Amendments To Drawing Figures

Serial No. 40/801,307

REMARKS

**FIG 17A**

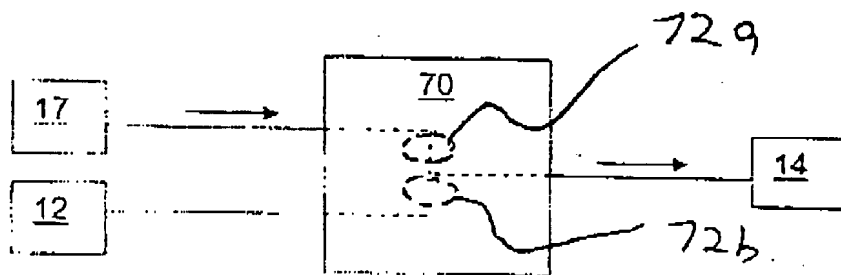
Figs. 11A-11C have been amended to schematically illustrate the two valve seats as requested in the Office Action. New drawing sheets are attached. The drawings are a schematic depiction of what is described in the specification. No new matter is added.

The drawings continue to be objected to by the Examiner. Examiner now states that not only the first position, second position and default neutral positions, but also the two valve seats, must be shown in the drawings or cancelled from the claims.

Responsive to this objection, applicants hereby submit corrected drawings, which now show schematically show these features.
